BUILDING CODE OF AUSTRALIA COMPLIANCE ASSESSMENT REPORT FOR DA SUBMISSION

PROPOSED BUILT-TO-RENT MIXED USE DEVELOPMENT WITH HOTEL SCHEME

153-157 WALKER STREET, NORTH SYDNEY

REPORT NO. ► 14002 Rev. 2

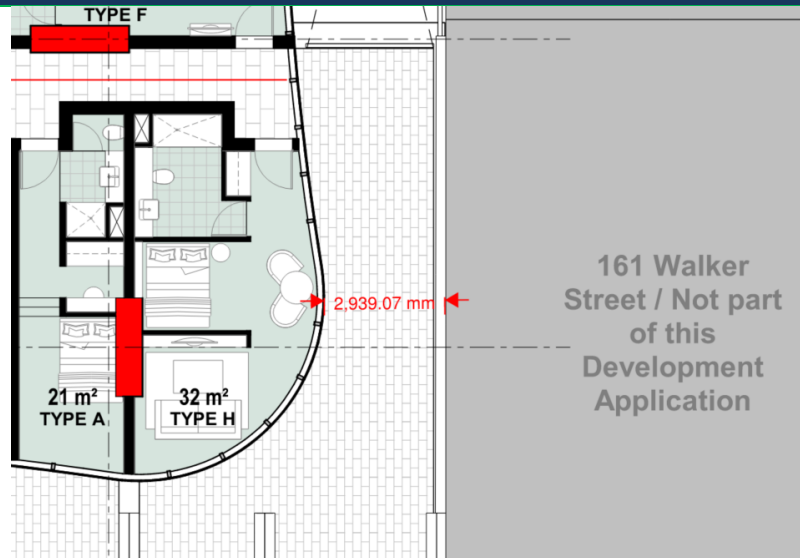
C2D14 Ancillary elements [2019: C1.14]	Capable of compliance subject to this issue being addressed by way of a Performance Solution by the fire engineer. Planter boxes are detailed in specific locations in the external façade of the building. The planter boxes are to be constructed of non-combustible material or addressed by way of a Performance Solution by the fire engineer at CC stage.

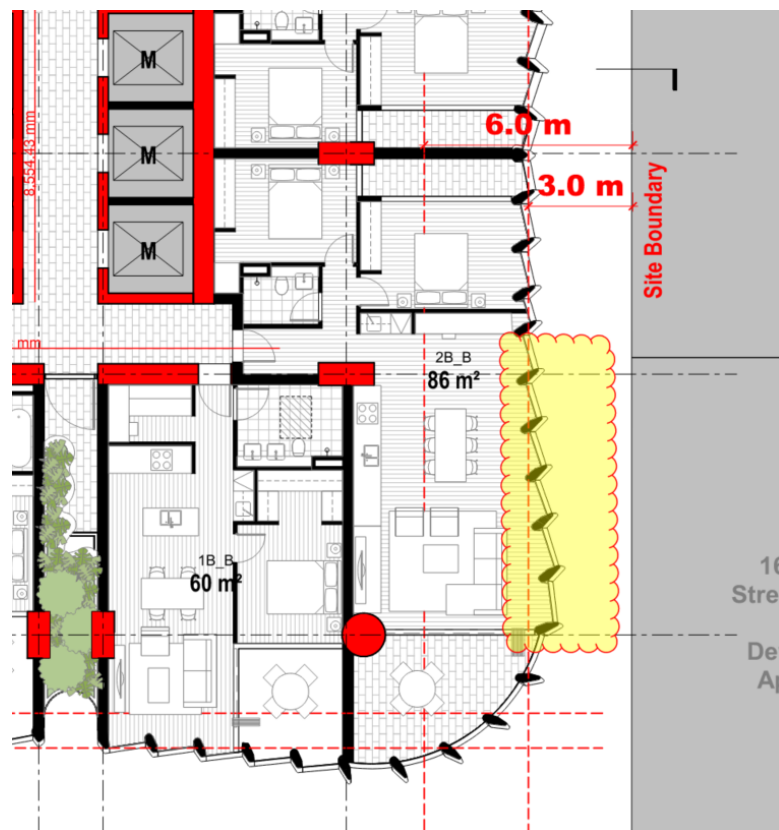
C3D9 Separation of classifications in the same storey [2019: C2.8]	Subject to the recommended design amendments or being addressed by way of a Performance Solution by the fire engineer, the proposal will comply. <u>Compliance commentary</u> - Fire separation in accordance with Table S5C11d is required to the following levels: <table border="1"><thead><tr><th>Level</th><th>Building Classifications</th></tr></thead><tbody><tr><td>Lower ground</td><td>Class 3 (hotel lobby), Class 5 (Staff ancillary areas), Class 6 (retail) & 7b (loading dock/ waste room and storage areas)</td></tr><tr><td>Ground floor</td><td>Class 2 & 3 (lobby) & Class 6 (restaurant & bar)</td></tr><tr><td>Level 5 & 6</td><td>Class 3 (hotel) & Class 9b (gym & wellness centre)</td></tr><tr><td>Level 33</td><td>Class 6 (dining and lounge) & Class 9b (gym)</td></tr></tbody></table> Table S5C11d: Type A construction: FRL of common walls and fire walls <table border="1"><thead><tr><th rowspan="2">Wall type</th><th colspan="4">FRL (in minutes): Structural adequacy / Integrity / Insulation</th></tr><tr><th>Class 2, 3 or 4 part</th><th>Class 5, 7a or 9</th><th>Class 6</th><th>Class 7b or 8</th></tr></thead><tbody><tr><td>Loadbearing or non-loadbearing</td><td>90/90/90</td><td>120/120/120</td><td>180/180/180</td><td>240/240/240</td></tr></tbody></table> - Separation between classifications to be provided as per the requirements of this clause. Where the FRL's are rationalised, this is to be done by way of a Performance Solution by the fire engineer at CC stage. - The architect is to confirm how fire separation will be achieved between on basement level 1 (Class 7a). Where separation is proposed by way of a roller	Level	Building Classifications	Lower ground	Class 3 (hotel lobby), Class 5 (Staff ancillary areas), Class 6 (retail) & 7b (loading dock/ waste room and storage areas)	Ground floor	Class 2 & 3 (lobby) & Class 6 (restaurant & bar)	Level 5 & 6	Class 3 (hotel) & Class 9b (gym & wellness centre)	Level 33	Class 6 (dining and lounge) & Class 9b (gym)	Wall type	FRL (in minutes): Structural adequacy / Integrity / Insulation				Class 2, 3 or 4 part	Class 5, 7a or 9	Class 6	Class 7b or 8	Loadbearing or non-loadbearing	90/90/90	120/120/120	180/180/180	240/240/240

BCA Clause	Deemed-to-Satisfy Provision to be addressed																								
	shutter. The omission of the insulation rating to the roller shutter providing fire separation between the loading dock area (Class 7b) on the lower ground floor and basement (Basement level 1) carpark is to be addressed by way of a Performance Solution by the fire engineer at CC stage. 																								
C3D10 Separation of classifications in different storeys [2019: C2.9]	Subject to the recommended design amendments or being addressed by way of a Performance Solution by the fire engineer, the proposal will comply. Fire separation in accordance with Table S5C11g is required to be provided in accordance with this clause. Table S5C11g: Type A construction: FRL of other building elements not covered by Tables S5C11a to S5C11f

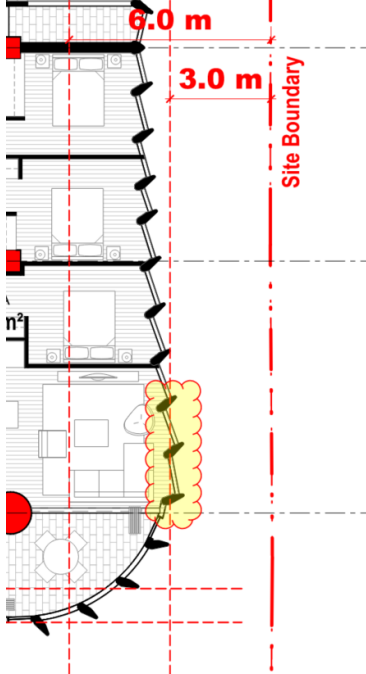
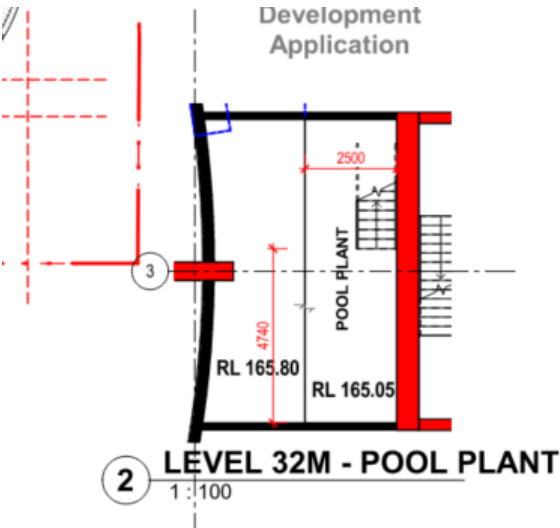
C4D3 Protection of openings in external walls [2019: C3.2]	Subject to the recommended design amendments or being addressed by way of a Performance Solution by the fire engineer, the proposal will comply. ▪ Openings within 3m of the side boundaries and are required to be protected in accordance with Clause C4D5. Examples highlighted in yellow below: ○ <u>Level 03 to 06;</u>

- Levels 8 to 14

- Levels 9 to 32, 34 - 49

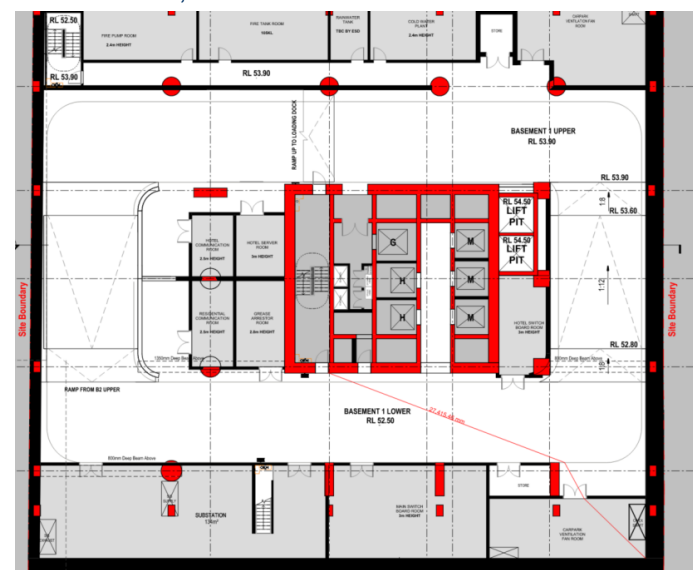
C4D4 Separation of external walls and associated openings in different fire compartments [2019: C3.3]	Subject to the recommended design amendments or being addressed by way of a Performance Solution by the fire engineer, the proposal will comply. The window to the gym on level 05 and within 4m of the wall to the SOU is to be protected in accordance with C4D5. 
C4D14 Openings in shafts [2019: C3.13]	Capable of compliance subject to this issue being addressed by way of a Performance Solution by the fire engineer.

BCA Clause	Deemed-to-Satisfy Provision to be addressed
	Provision of fire rating to the chute collection room in lieu of the base of the chute will be subject to a Performance Solution prepared by the fire engineer at CC stage.
NSW D2D3 Number of exits required [2019: D1.2]	Capable of compliance subject to this issue being addressed by way of a Performance Solution by the fire engineer. - A single exit is provided to Basement 1 lower level. It should be noted the exit stairway within the substation will not be accessible to occupants evacuating the building as it is assumed will be locked at all times. The 1:12 to 1:8 ramp is not considered an egress pathway as it will not be provided with handrails to at least one side as required by Clause D3D22. <i>This is to be addressed by way of a Performance Solution by the fire engineer.</i> - A single exit is provided from level 32M Pool plant area in lieu of 2 exits. <i>This is to be addressed by way of a Performance Solution by the fire engineer.</i>

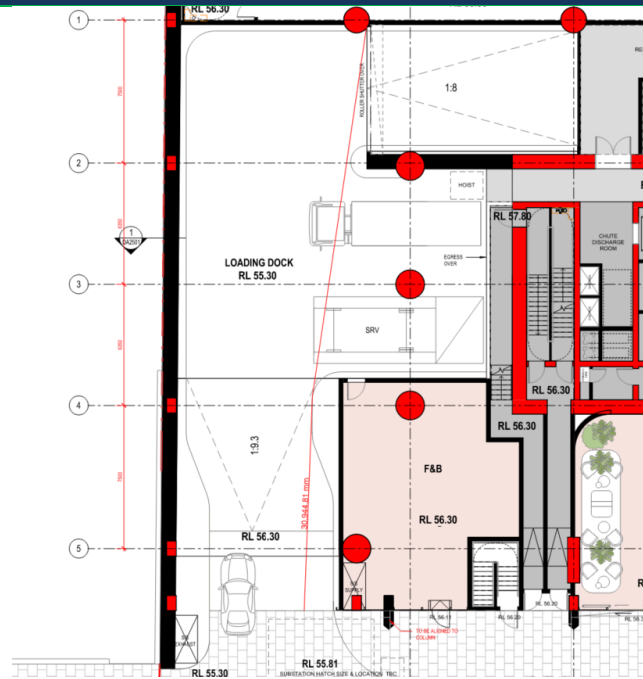
D2D5 Exit travel distances [2019: D1.4]	Capable of compliance subject to this issue being addressed by way of a Performance Solution by the fire engineer. The following areas are provided with travel distances that exceed the maximum permitted under this clause: - Basement levels – travel distance within the plenum has not been considered as it has been assumed the doorway into the plenum is an access hatch in lieu of a larger doorway. - Basement levels 2 to 10 – Up to 27m to a point of choice to 2 exits in lieu of 20m;

- Basement level 1 – Up to 27.5m to an exit in lieu of 20m from the carpark ventilation fan room;

- Lower ground floor – Up to 31m to an exit from the furthest point within the loading dock.

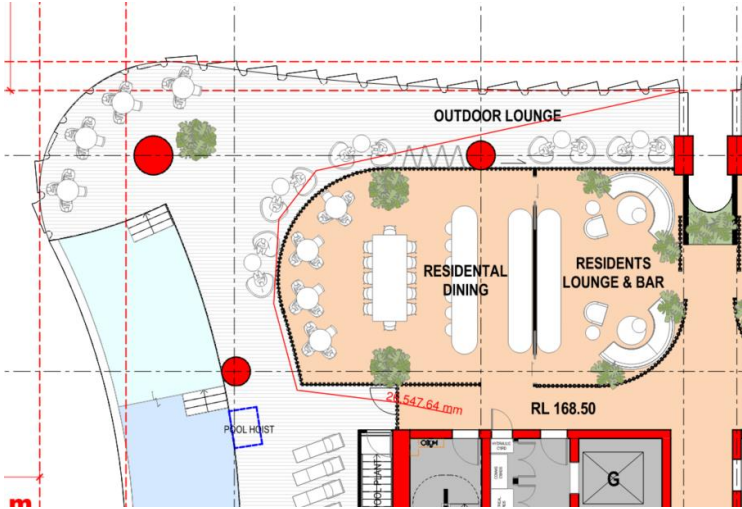
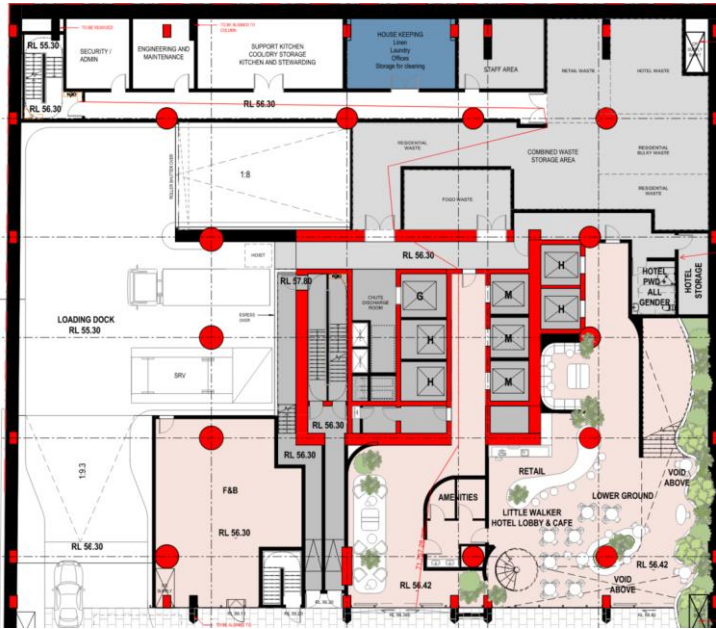
- Levels 01 to 06 – Up to 16.7m to a point of choice to 2 exits in lieu of 6m from the furthest units (Type F room);

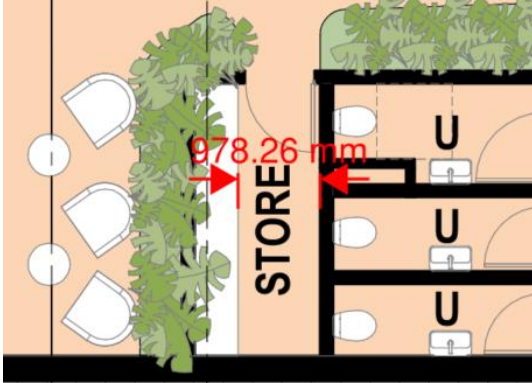
- Level 05 – Up to 36.5m to a point of choice to 2 exits from the furthest corner of the terrace serving the gym;

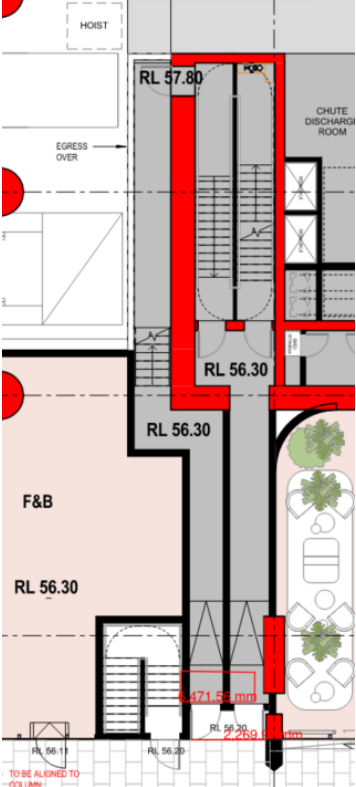
- Level 06 – Up to 43m to a point of choice from the furthest point of the pool area.

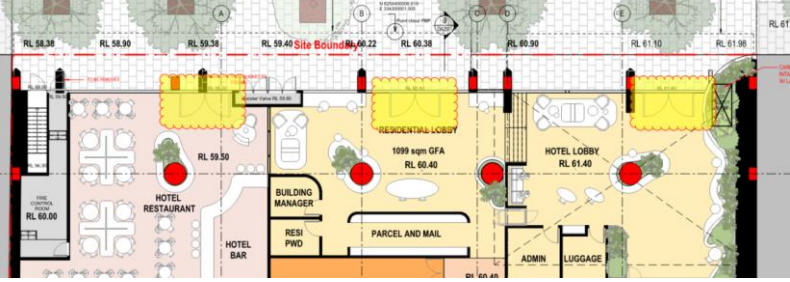
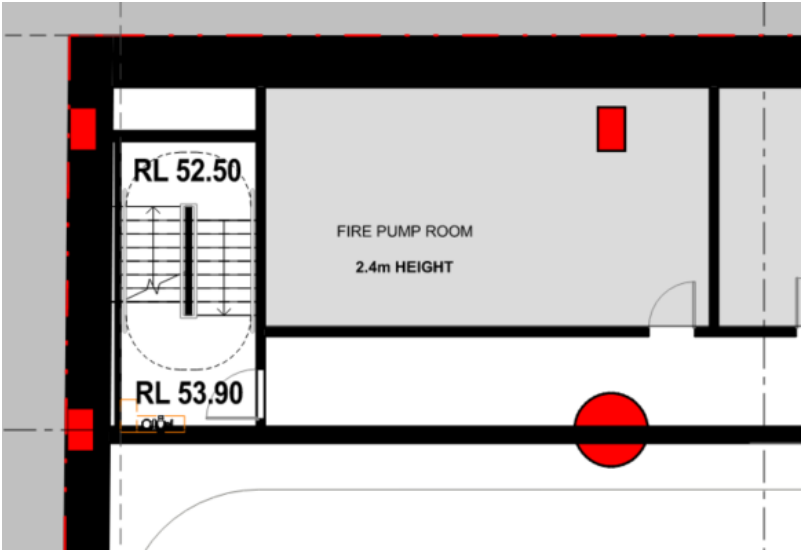
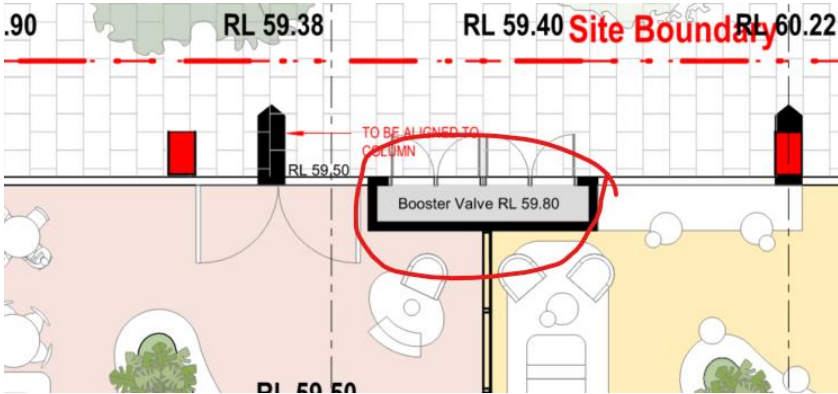
BCA Clause	Deemed-to-Satisfy Provision to be addressed
	 Level 33 – Up to 26.5m to a point of choice to 2 exits in lieu of 20m from the furthest point of the outdoor lounge area.  <i>The extended travel distanced listed above are to be addressed by way of a Performance Solution by a fire engineer at CC stage.</i>
D2D6 Distance between alternative exits [2019: D1.5]	Capable of compliance subject to this issue being addressed by way of a Performance Solution by the fire engineer at CC stage. Lower ground floor – The distance between alternate exits is 71m in lieu of 60m.

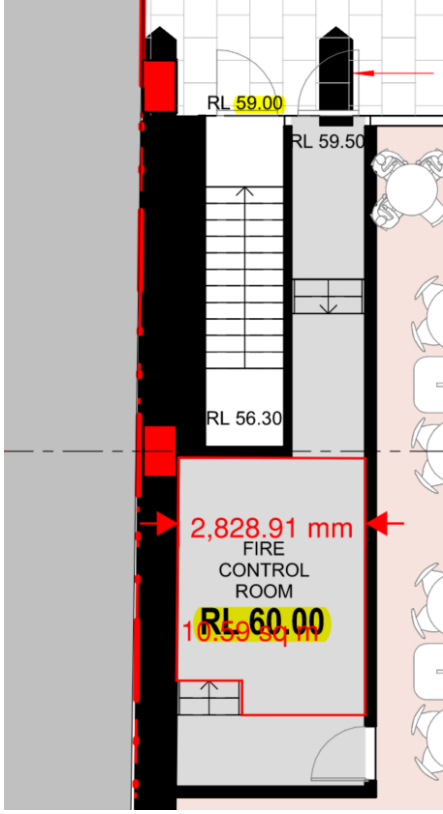
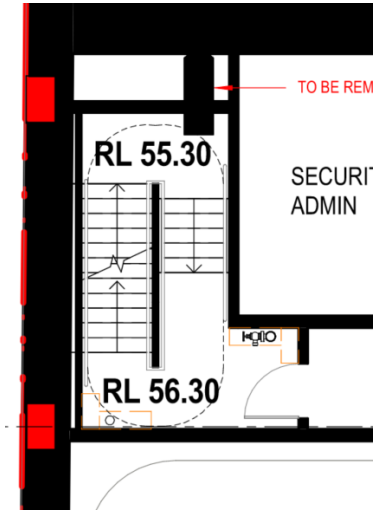
BCA Clause	Deemed-to-Satisfy Provision to be addressed
	<i>This is to be addressed by way of a Performance Solution by a fire engineer at CC stage.</i>
NSW D2D8 Width of exits and paths of travel to exits [2019: D1.6(b), (c), (d) and (e)]	Subject to the recommended design amendments to the lower ground floor and level 6 and this issue being addressed by way of a Performance Solution by the fire engineer on the other levels, the proposal will comply. The following area provides an egress width of less than 1: - Basement levels 1 to 10, ground floor, level 01 to 51 – Pathway between the stair pressurisation shaft and electrical cupboards provides a width of 870mm;  - Lower ground floor – between the sofa and the table (670mm noted) located in the little walker hotel lobby and cafe;  - Level 06 – 980mm within the store room to the pool area (between the wall and the joinery);

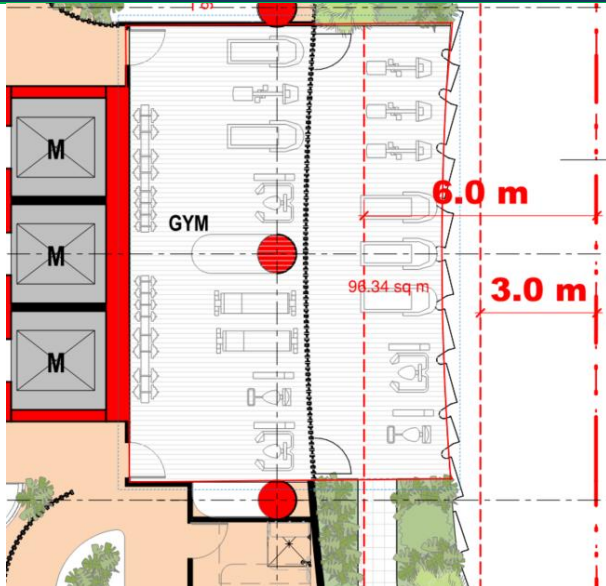
- Level 06 (Swimming pool) – 44 persons. On the basis the pool will be used by persons staying in the hotel, the reduction in sanitary facilities within the pool area has been deemed acceptable. However, the certifier is to confirm this is acceptable.

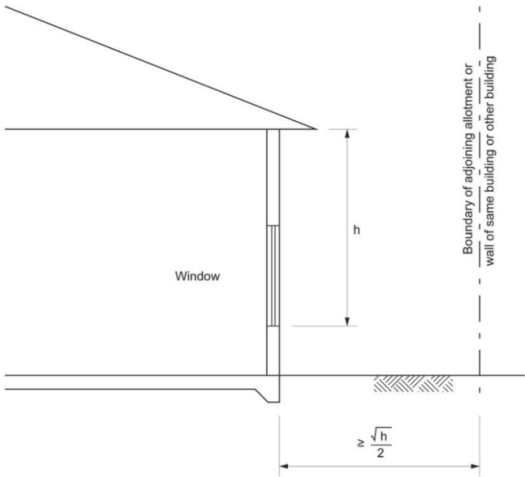
- Level 33 (Swimming pool) – 53 persons. On the basis the pool will be used by persons staying in the hotel, the reduction in sanitary facilities within the pool area has been deemed acceptable. However, the certifier is to confirm this is acceptable.
